Farlands, Cranbrook, Devon

Road Safety Audit Stage 1

TMS reference no: 17745

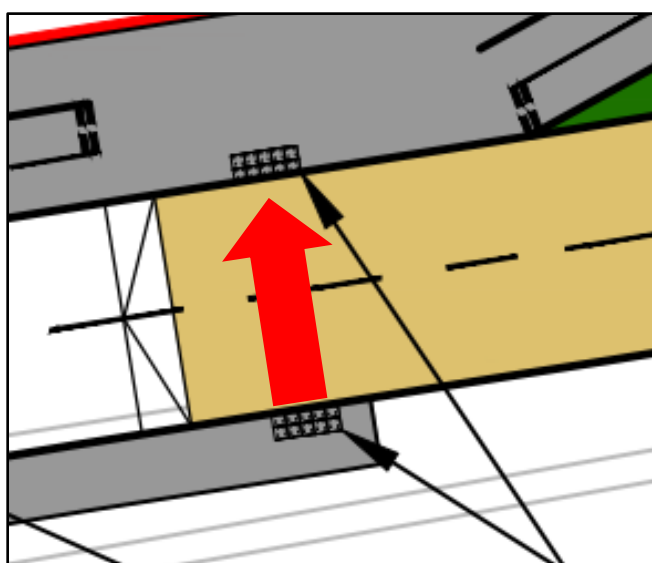
Location – Site access priority junction onto London Road

Summary: Skidding and loss of control collisions.

It was noted that an existing gully was located in the carriageway at the proposed site access. The metallic gully cover might have poor surface friction levels, especially in wet and icy weather conditions. This could increase the risk of loss of control collisions for vehicles turning in and out of the development access.

The gully should be relocated out the development access junction and the drainage should be reviewed at detailed design stage.
